**RFI**

RFI #: 187  
 Date: 9/4/2012  
 Job: EB-02 Keller Springs Lofts  
 Phone: 877-777-5115

Subject: Parapet walls supports

Drawing: 1/SS.02, 2/4.3  
 Cost Impact: None  
 Spec Section:  
 Schedule Impact: None

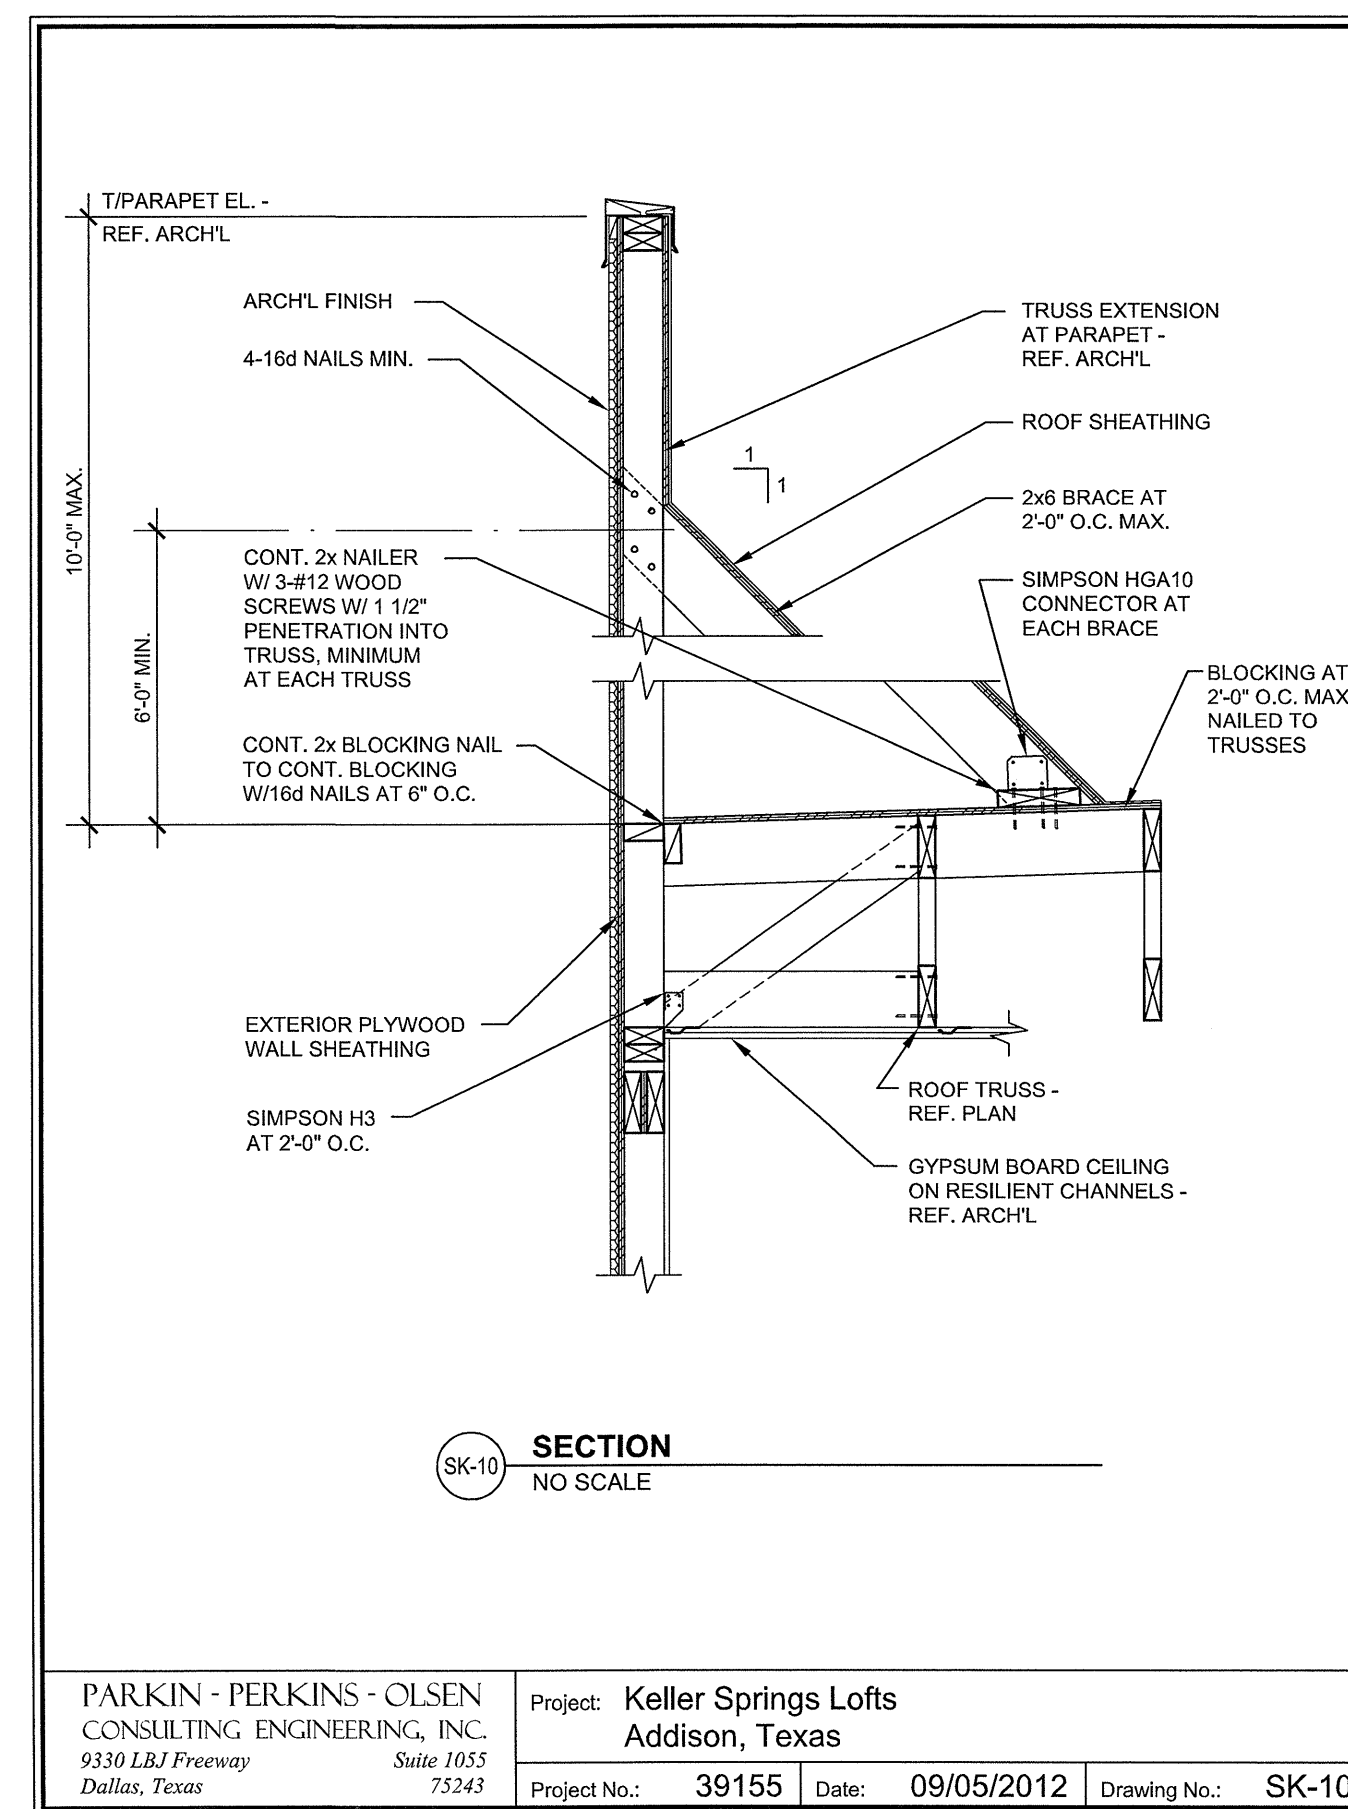
Request: We have parapet walls that are 10' tall, an example of this is 1SS.02 and 2/4.3 is there a minimum height that we should install additional support that ties back into the roof system for wind load? If so please provide the height and a drawing showing us how to structurally tie them in.

Please see attached sketches.
